SERVICE LETTER SL48 65-45104

1. Release Date: 03/22/2021
2. Service Letter No.: SL48 65-45104
3. Subject: Gravel Deflector
4. Part/Assembly No.: 65-45104
5. Float Model Affected: 6650
6. Compliance: **Mandatory** **Recommended** **Optional**
7. Approval: All information provided is in accordance with approved data.
8. Corrective Action: Non-required.
9. Time Required: **Approximately 1 hour.**
10. Payments: Credit to Customer Under Warranty Customer Pays

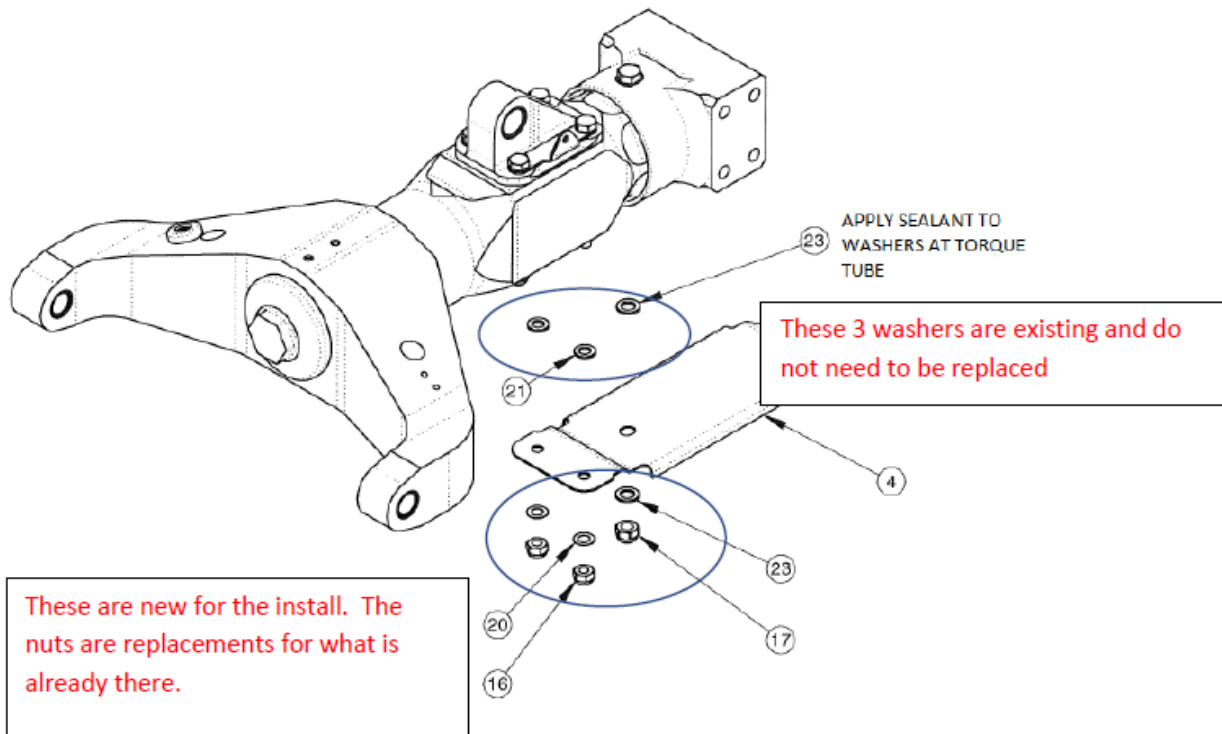
NOTE CHANGES ON DRAWING

Note 7 (NEW):

- 7. OPTIONAL INSTALLATION OF 65-45104 DEFLECTOR IN ACCORDANCE WITH SHEET 4 OF THIS DRAWING. ASSEMBLY NUMBER WITH THIS DRAWING IS 65-4510-2

Note 8 (NEW)

- 8. 65-45100 LOWER MAIN GEAR ASSEMBLIES SHOWN WITH RIGHT HAND SIDE VERSION SHOWN UNLESS OTHERWISE NOTED. POSITION ZINC ANODE TO THE OUTBOARD SIDE.

Note 7 introduces the dash number designating inclusion of the deflector. Note 8 clarifies assembly orientation. The only difference between LH and RHS is the position of the sacrificial anode.)
